MEMORANDUM

SUBJECT: Special Use Permit and Site Plan Approval – 440 State Street

DATE: June 4, 2026

Request: Special Use Permit and Site Plan Approval to construct a 544 square-foot (SF) coffee shop with an accessory drive-through and associated site improvements on lands that currently comprise **430 State Street**, Parcel Number 12-03-220.200 and **440 State Street**, Parcel Number 12-03-220.300.

Date	MAY 2026
Scale	AS SHOWN
Sheet Number	C102
Project Number	5074.001.001

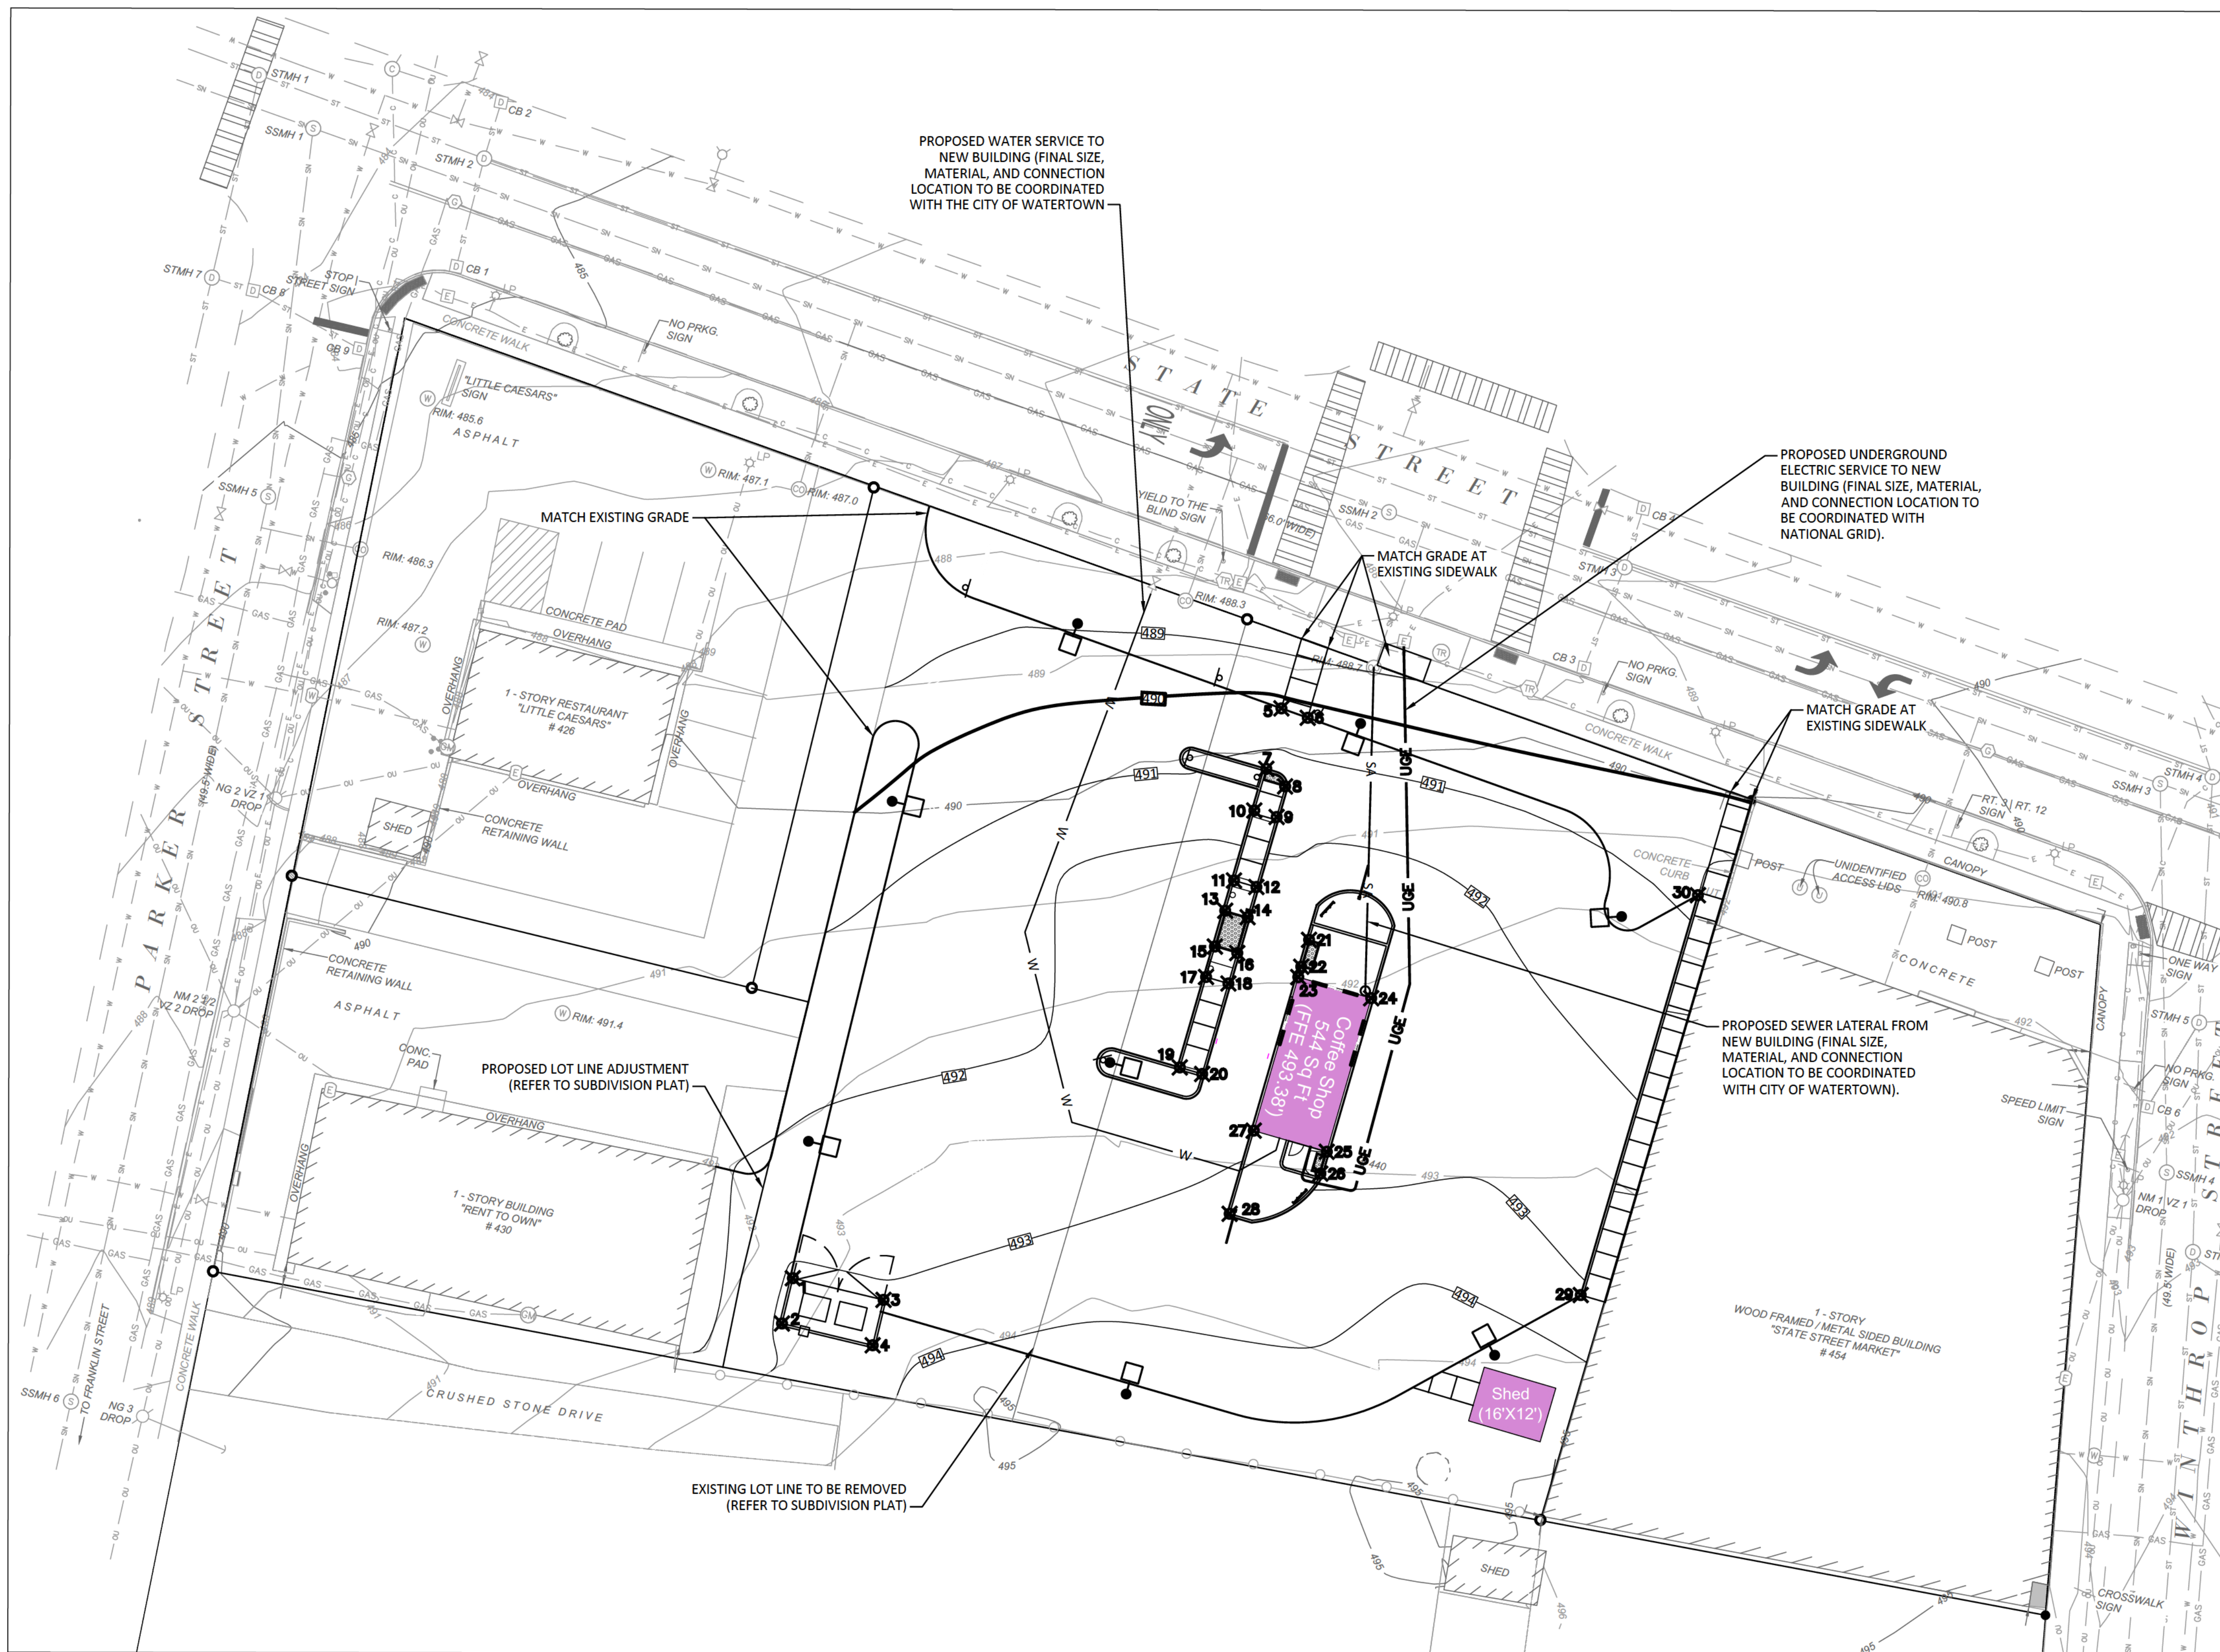
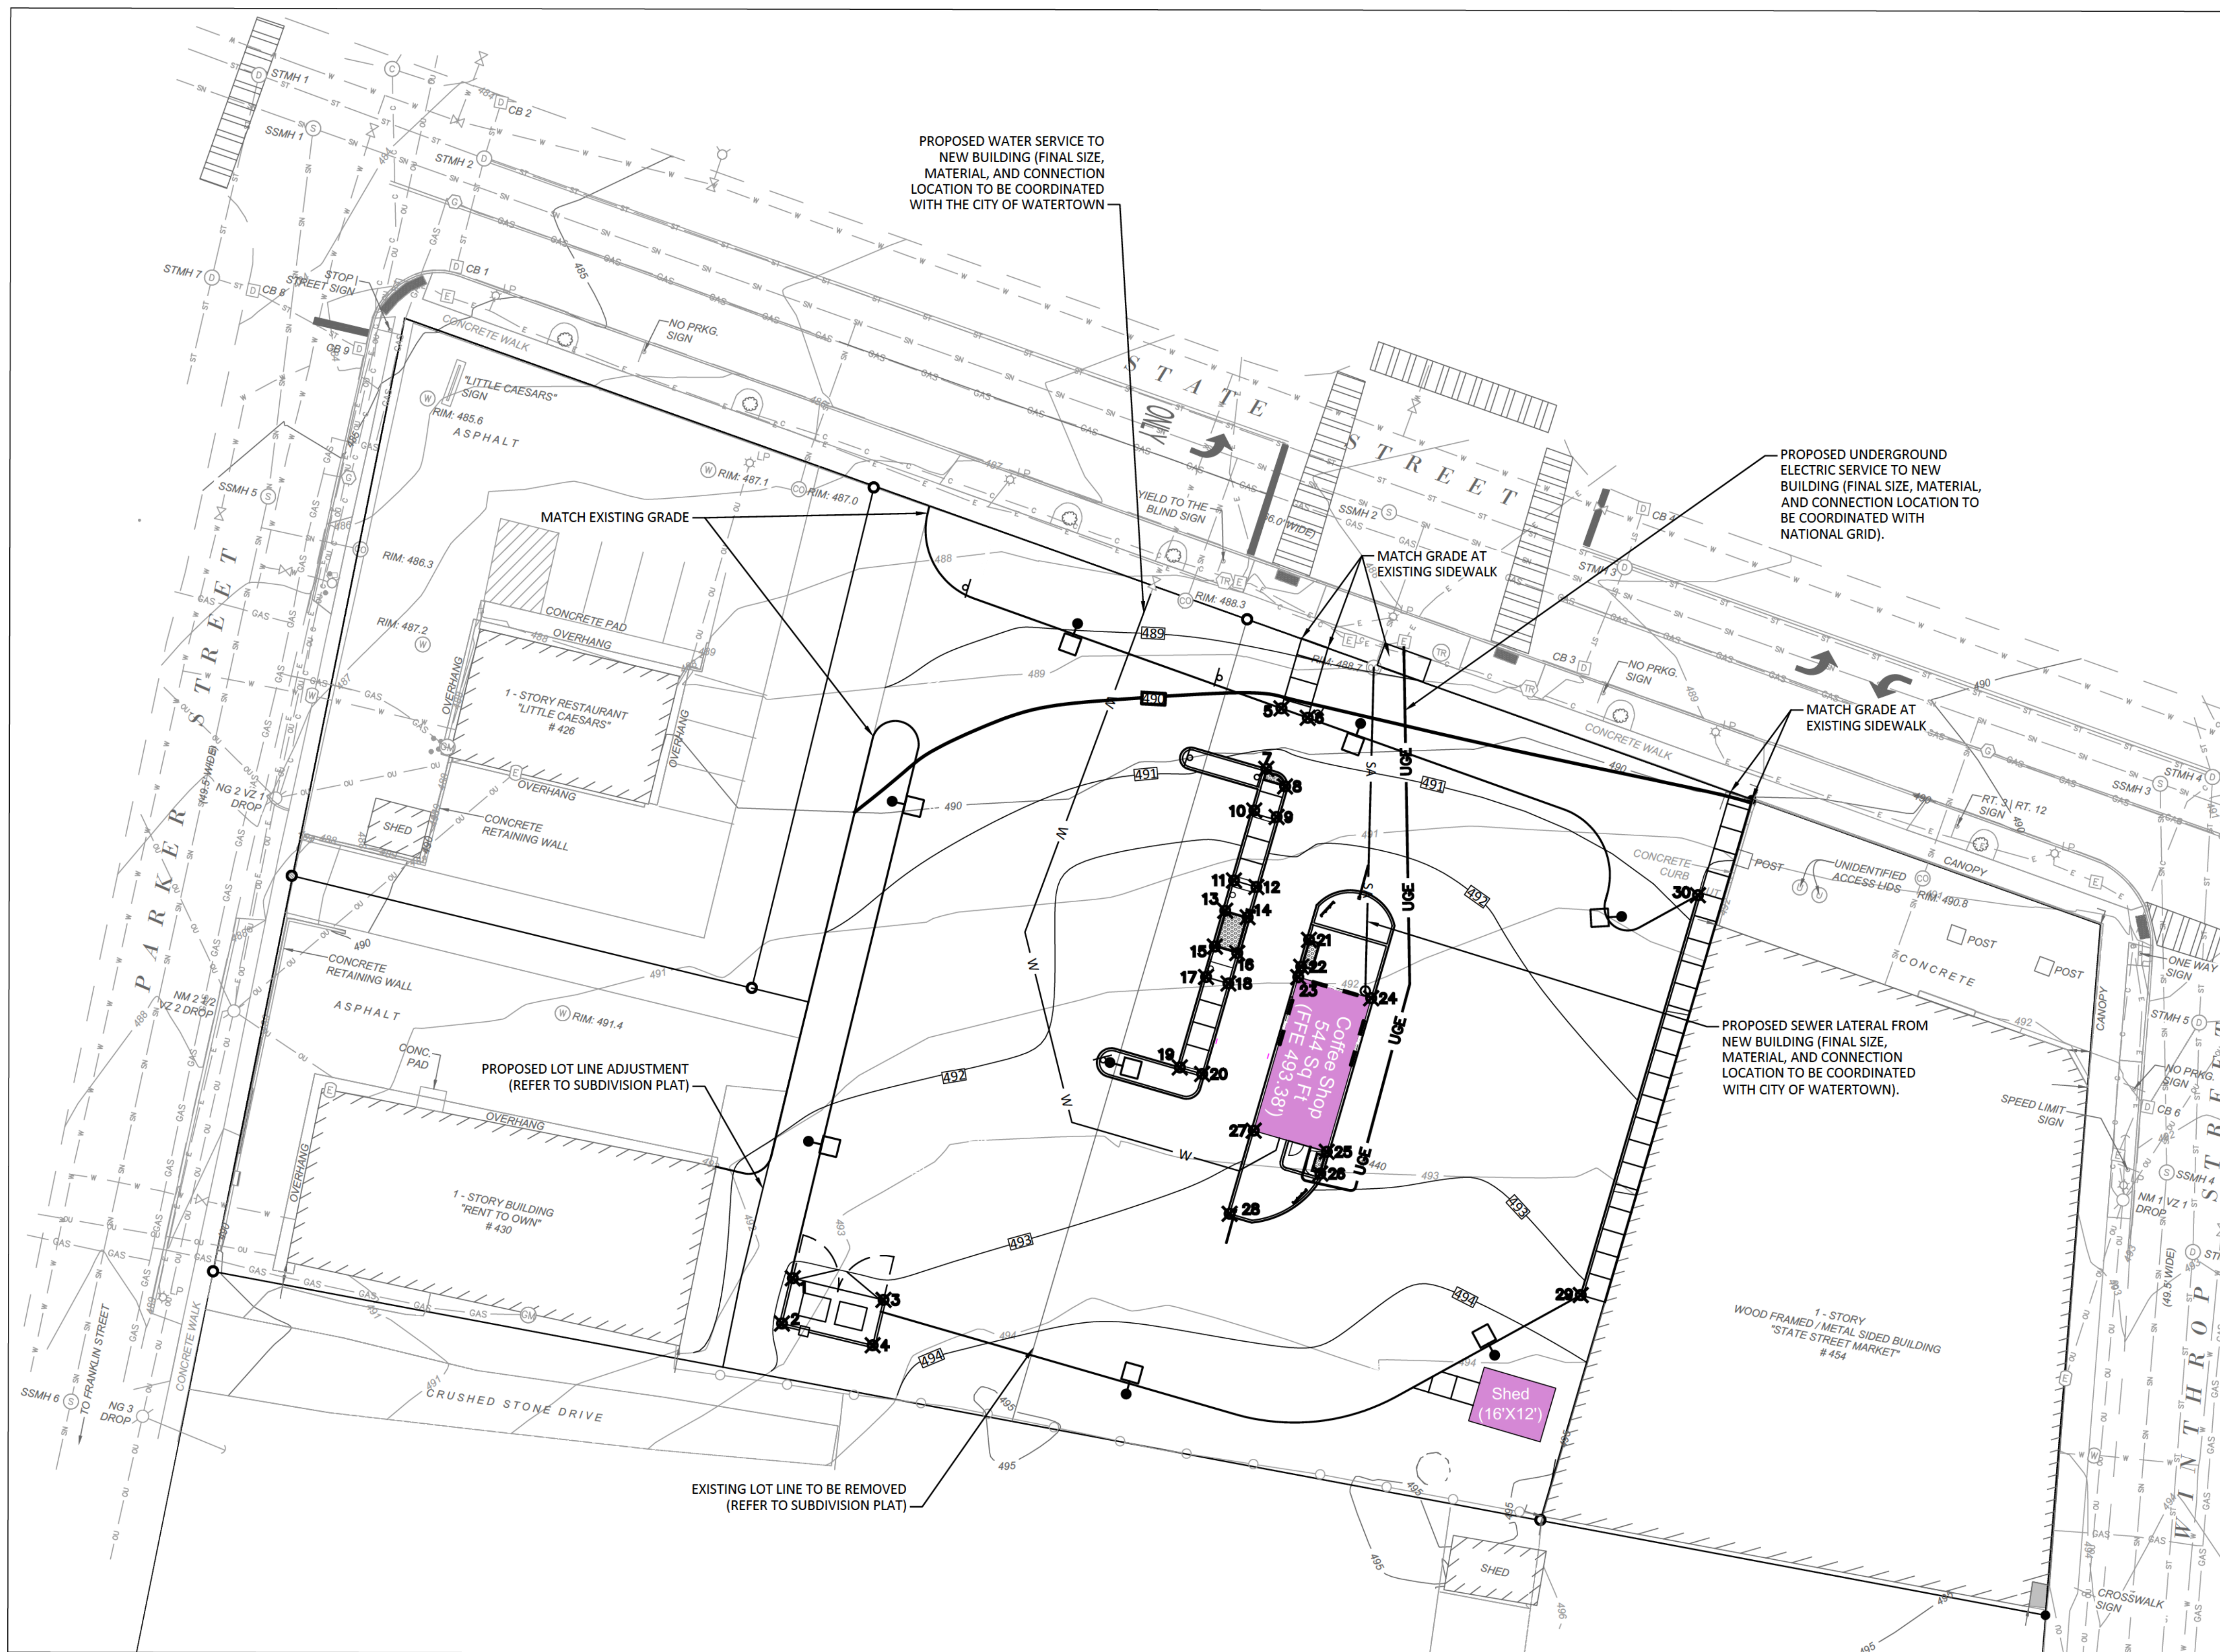
pave over almost all the existing gravel, creating a significant amount of impervious surface where infiltration was previously possible. The applicant also does not propose any catch basins on the site. This will result in substantial sheet flow and runoff into the State Street ROW. The applicant also did not provide any stormwater calculations.

Given the proposed increase in impervious surface and the lack of stormwater calculations, the applicant has not submitted sufficient information for the Planning Commission to make an informed decision about Special Use Permit Criterion F. The applicant must submit stormwater calculations, to the detail required by the City Engineering Department, so that Staff can make an informed recommendation to the Planning Commission regarding this Criterion.

5. The applicant shall identify proposed hours of operation.
6. The applicant shall submit a revised grading and drainage plan and stormwater calculations to the City Engineering Department in sufficient detail to determine the impact on public facilities.
